FREIA Status Report

Follow-up Meeting UH2015/06
(vertical cryostat, Gersemi)

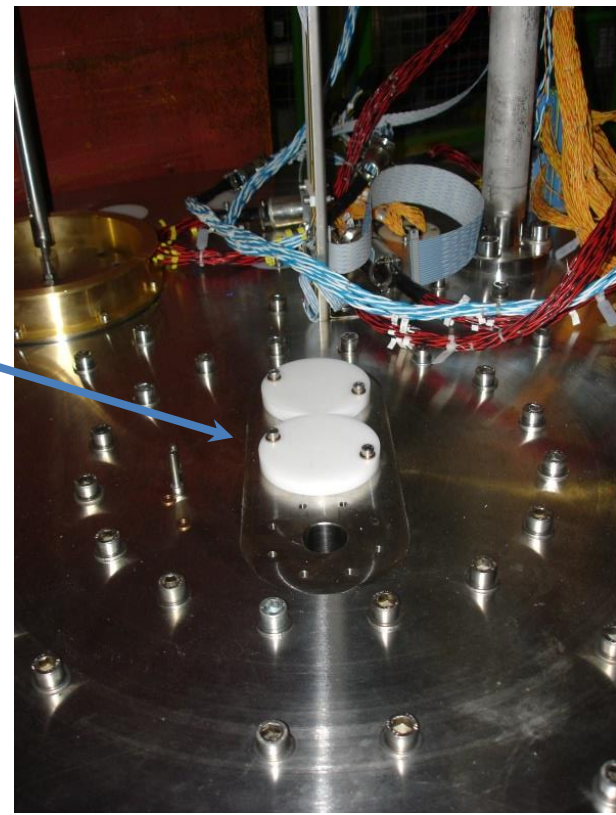
- No need for 80 K measurements: no need to redefine piping to accomplish this temperature in the VCS
- Need more openings in the top flange and in the λ -plate

Missing

- burst disk
- mole shafts (x3)

In general, add as many feedthroughs as possible (on both top flange and through λ -plate)

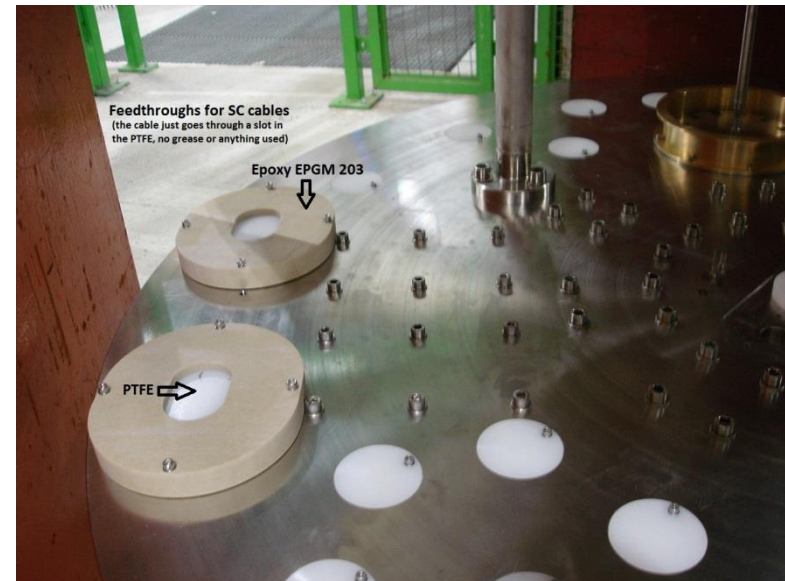
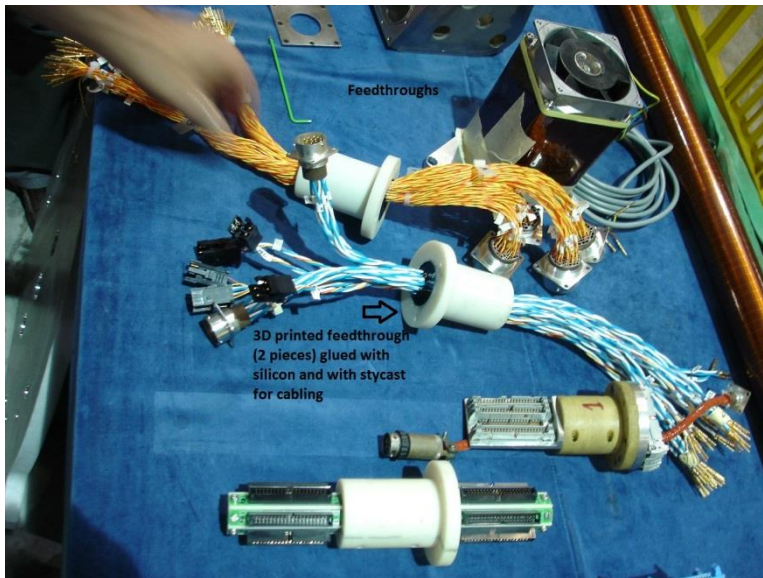
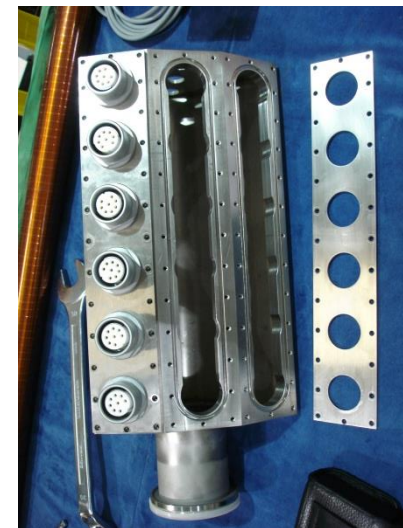
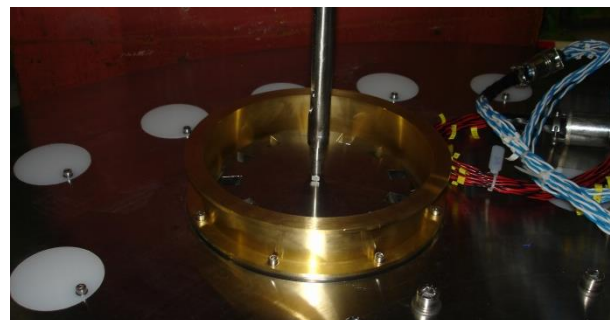
- The weight of the insert is very important
 - The crane will be upgraded to max. 7 ton
 - The magnet weight is 5.2 ton
 - Thus the insert containing all equipment (current leads, connectors, valves, etc) **must** be lower than 1.8 ton
- The flatness of the round collar where the λ -plate sits and the λ -plate itself (0.1 mm) is an issue
 - For the round collar first weld and then machine
- The feedthroughs are also an issue and grease must not be used

- Because of necessary HV tests for the magnet:
 - All equipment in contact with magnet and ground **must** be able to withstand 500V, but have to be tested at 3 kV for at least one minute
 - Proper HV insulation is needed
 - It **must** be possible to remove all connections from the top of the insert
 - All subsystems (VB, VCS, heater,...) must be properly grounded
